**AGENDA
TECHNICAL REVIEW COMMITTEE
REGULAR MEETING
MAY 22, 2025
10:00 AM
CITY HALL COMMISSION CHAMBERS
204 ASH STREET
FERNANDINA BEACH, FL 32034**

Technical Review Committee: Application - Submission #15864

Project Type*	Project Name
Site Plan Review	Replat Lot 8 Block 233

REPLAT LOT 8
BLOCK 233
6 TOWNHOMES

GEOMETRY PLAN

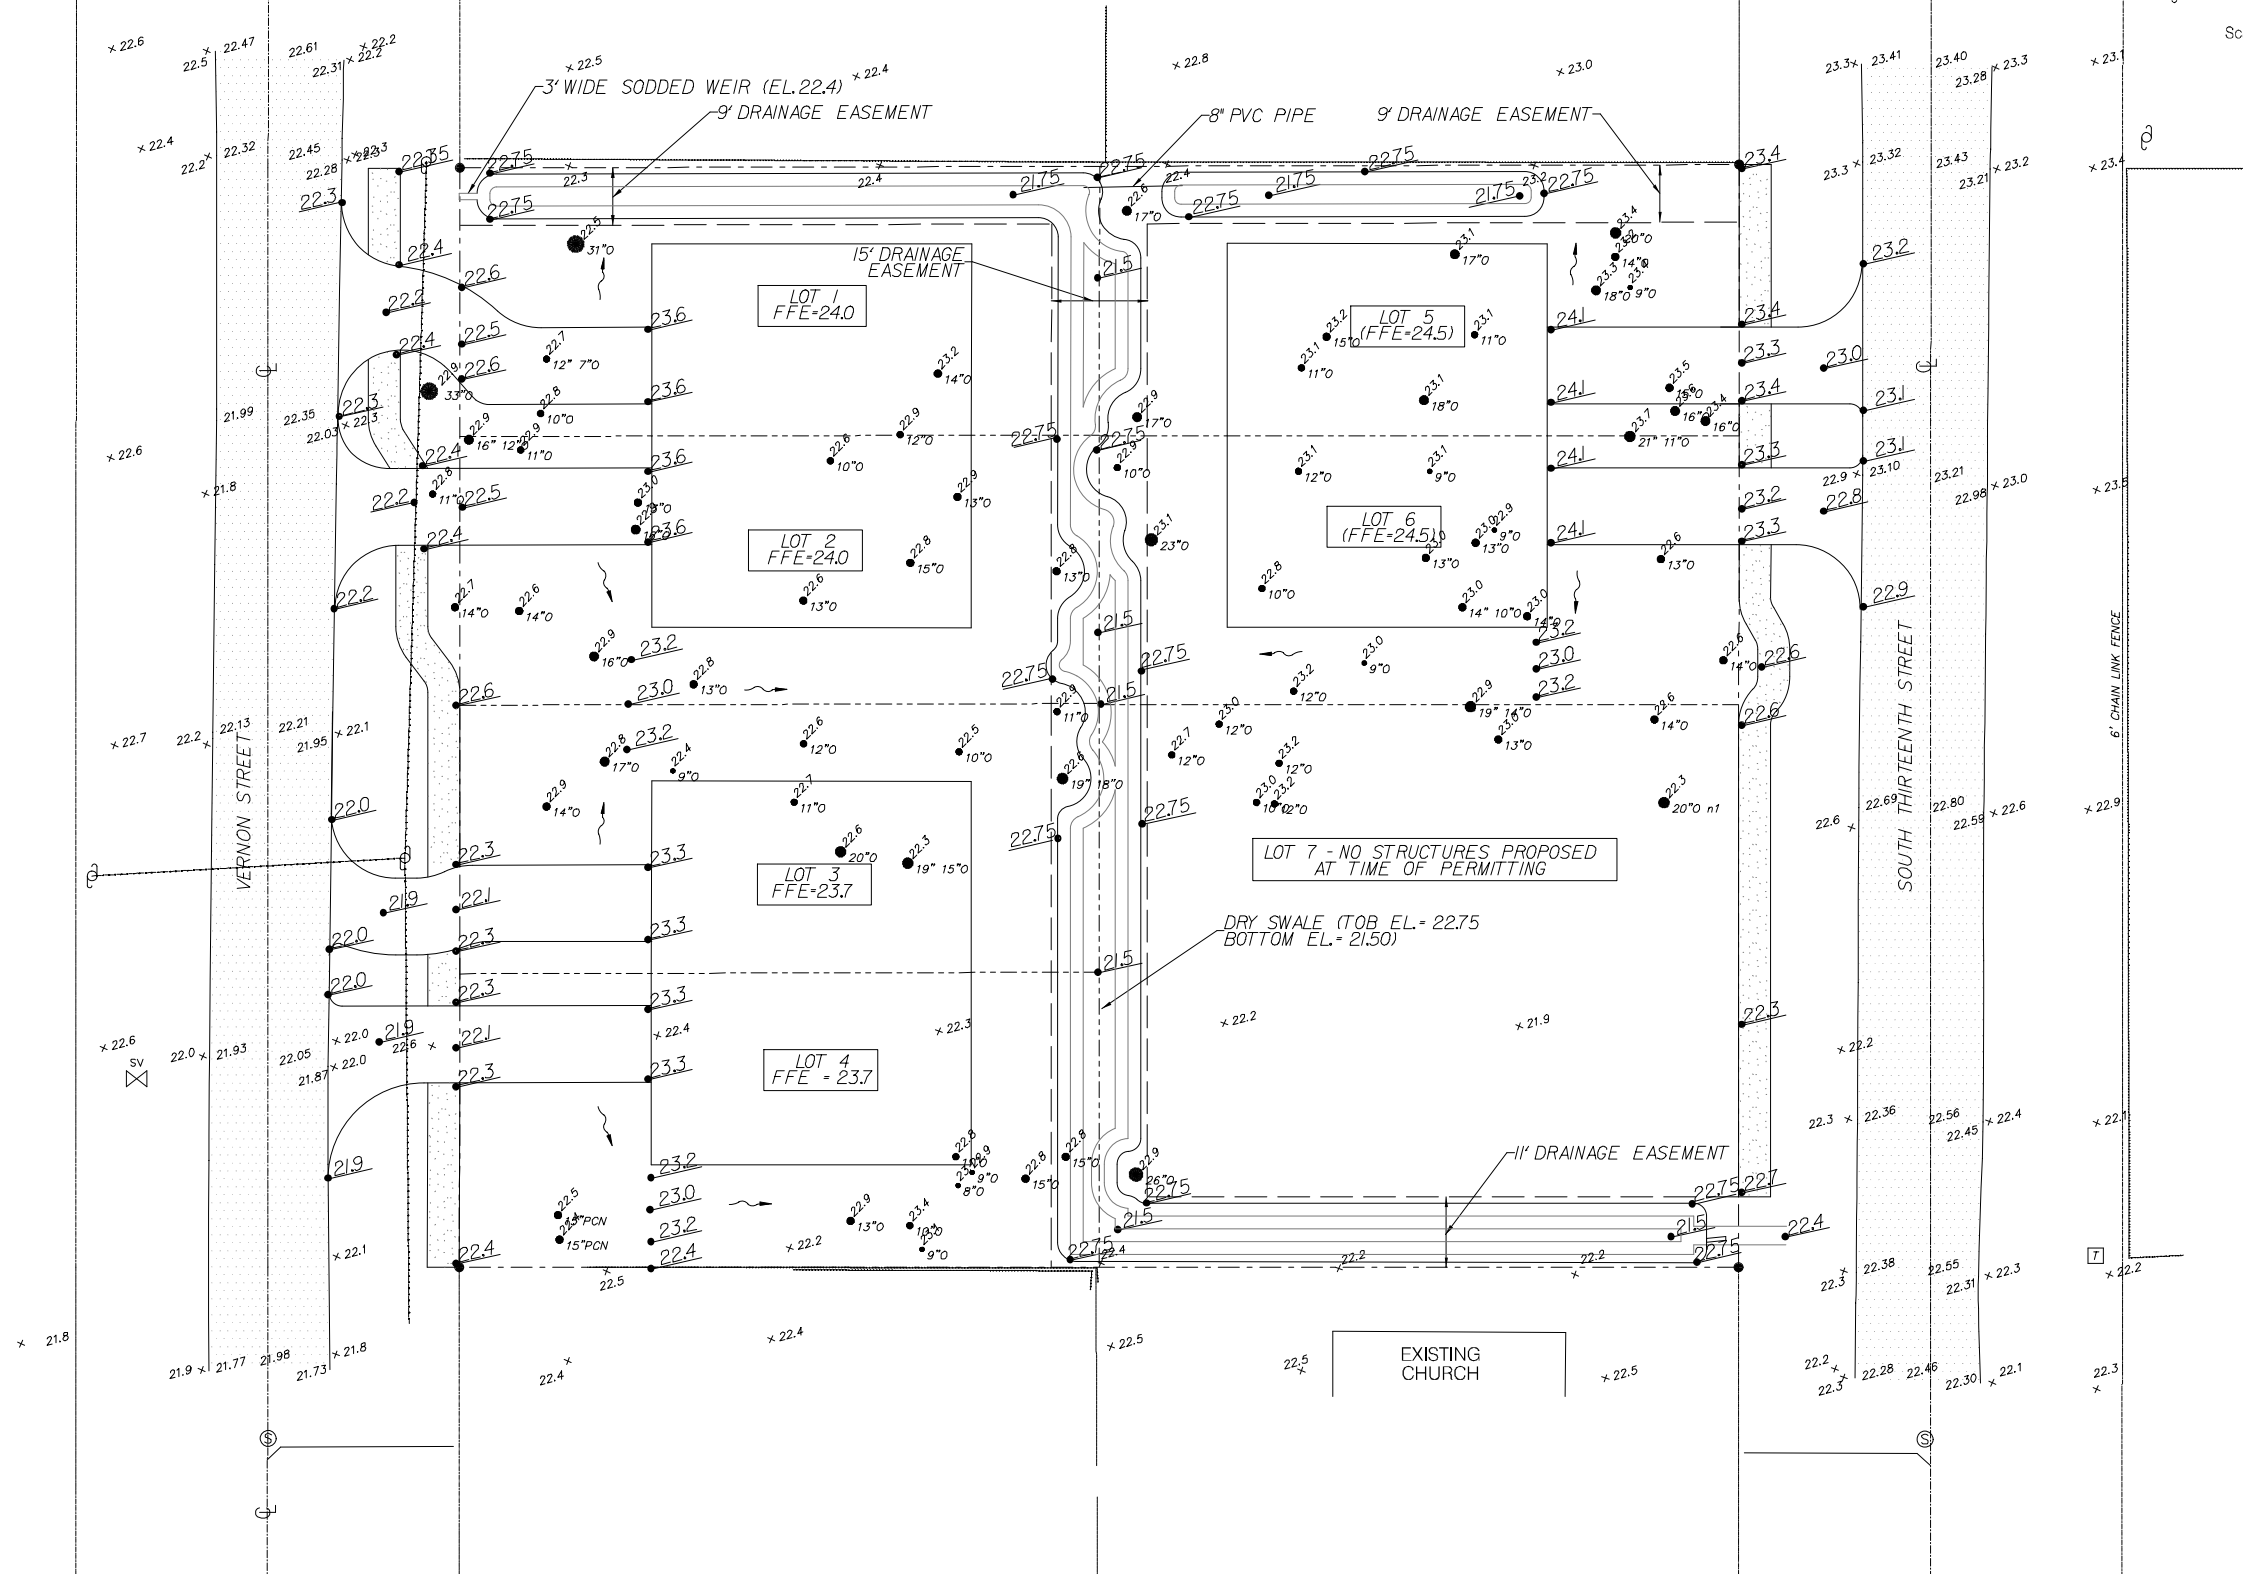
Please show the building setbacks for each lot.

Please show the building setbacks for each lot. Setback lines are shown but need to add proposed setback dimensions and setback requirements

Sheet No.
TREE-1

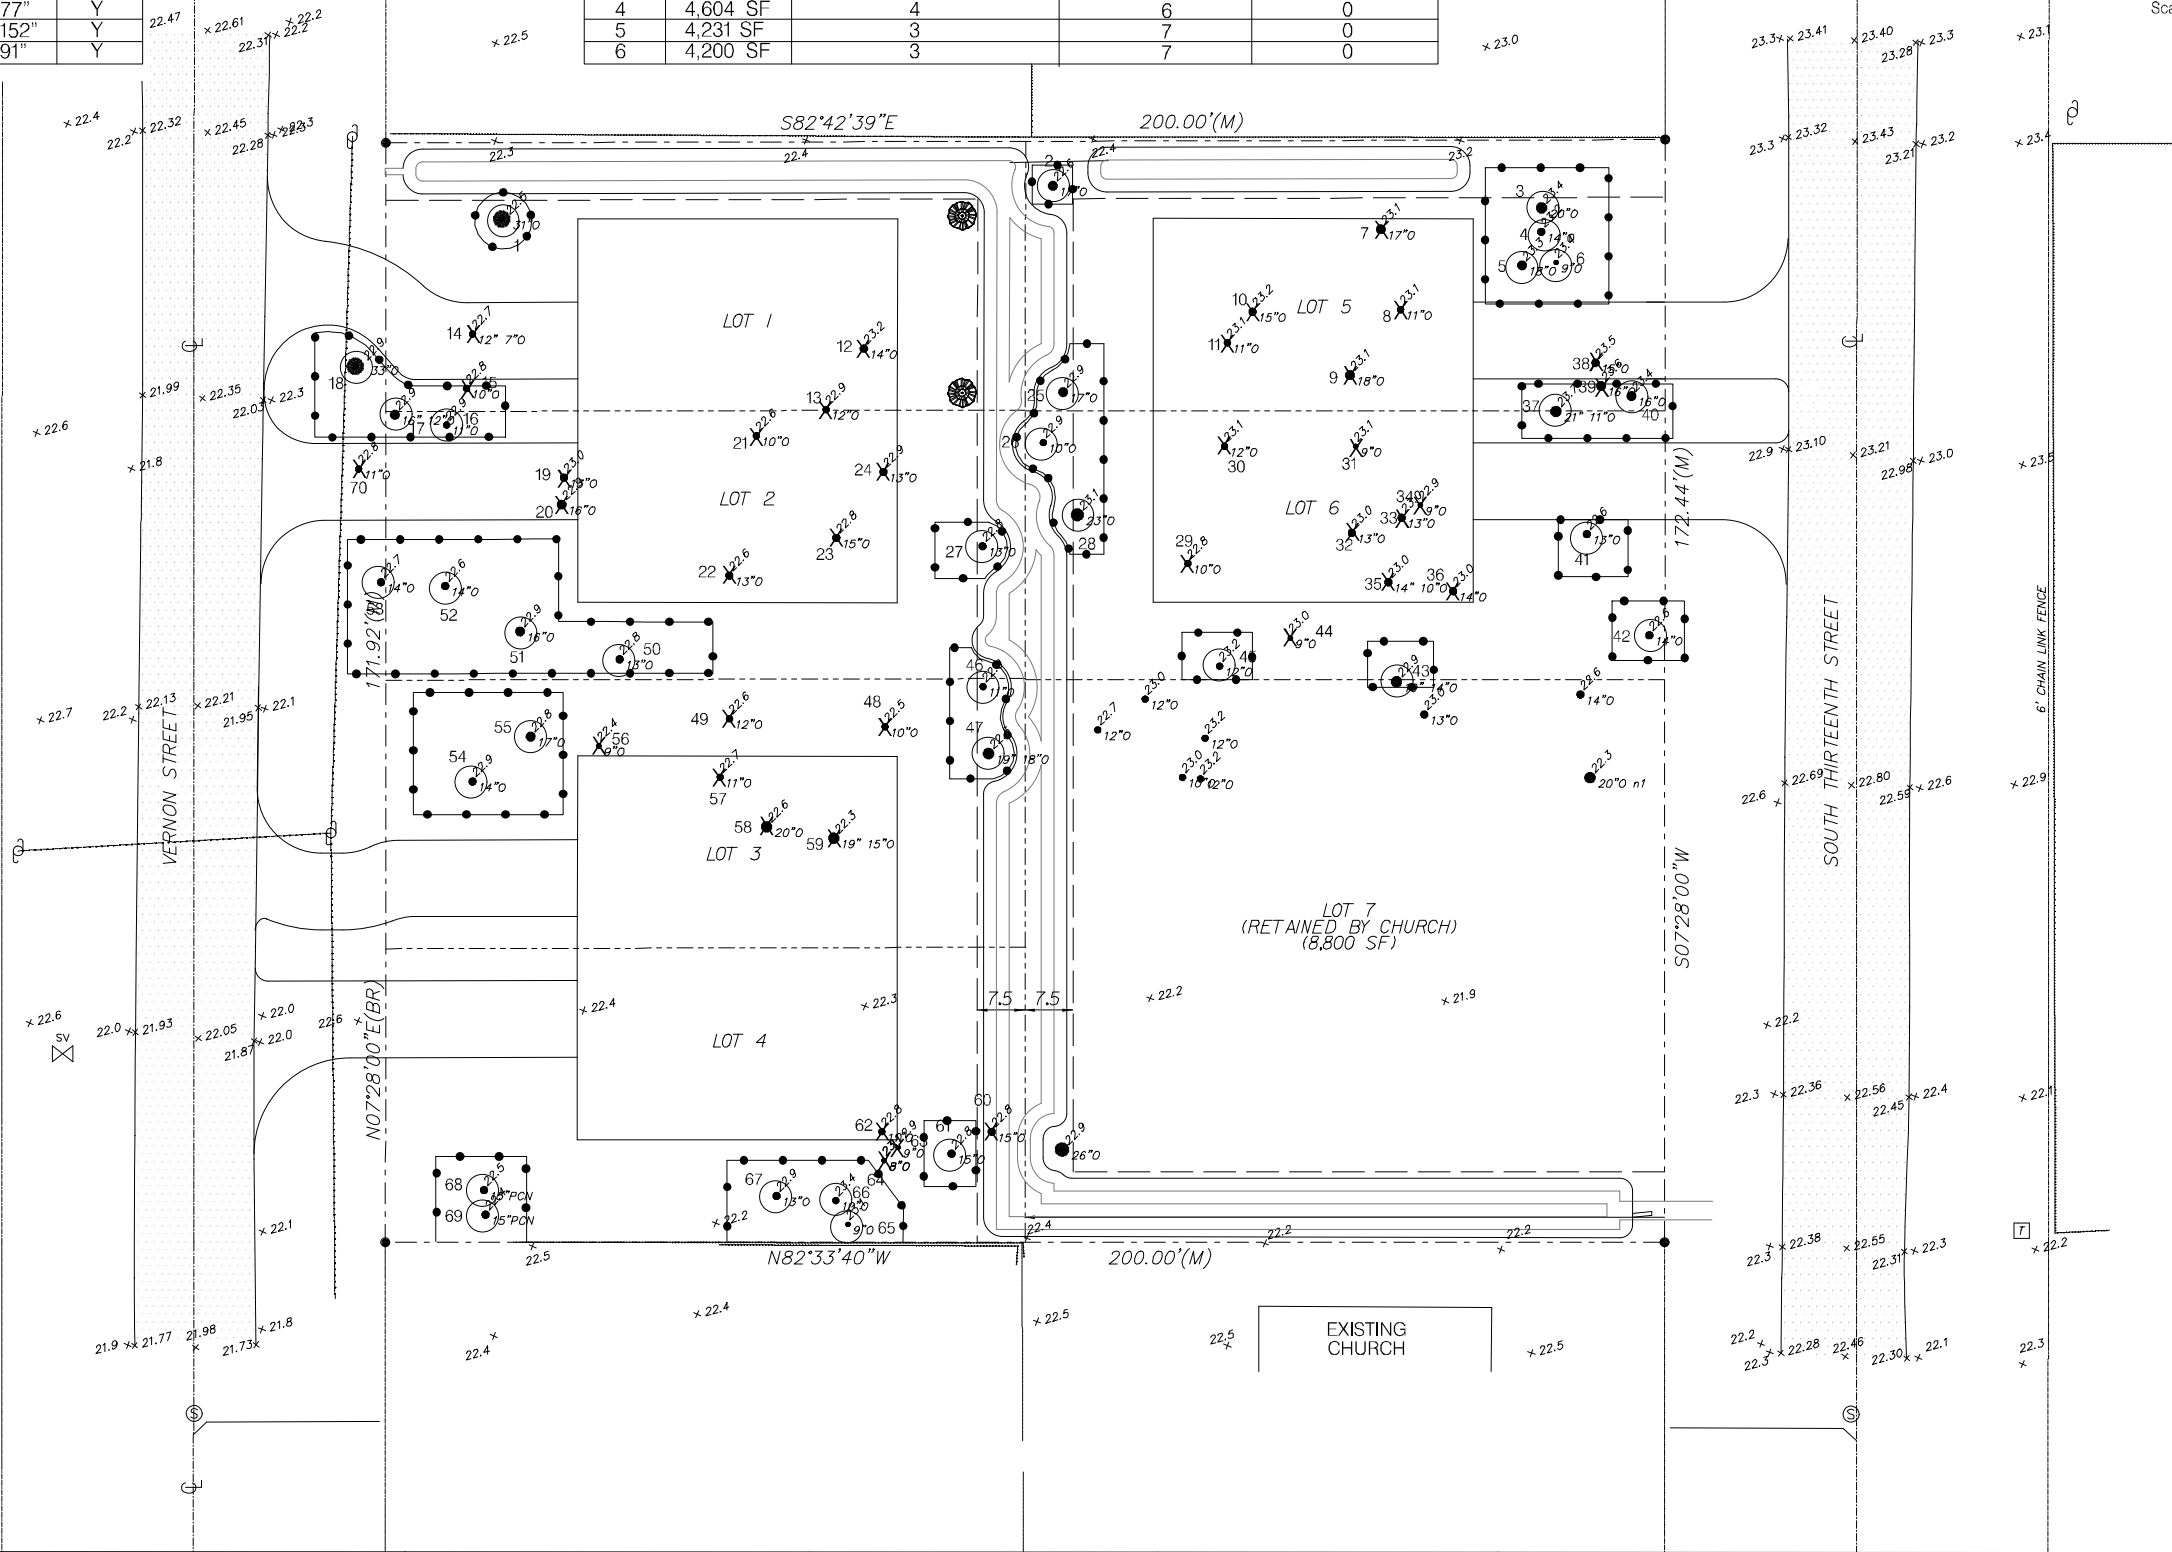
Per LDC 4.05.04 A landscaping plan shall demonstrate compliance with the standards of this section. Single-family Detached and Two-family Duplex Residential Development Single-family and two-family development must include, at a minimum, two (2) native, shade trees for every 2,500 square feet of lot area or fraction thereof.

At least four (4) native trees may be located in the front, side, or rear yard. *Suggest providing information/calculations in table form on landscape plan.*

Min shade tree requires have been met per sheet Tree-1. dn 5/15/25
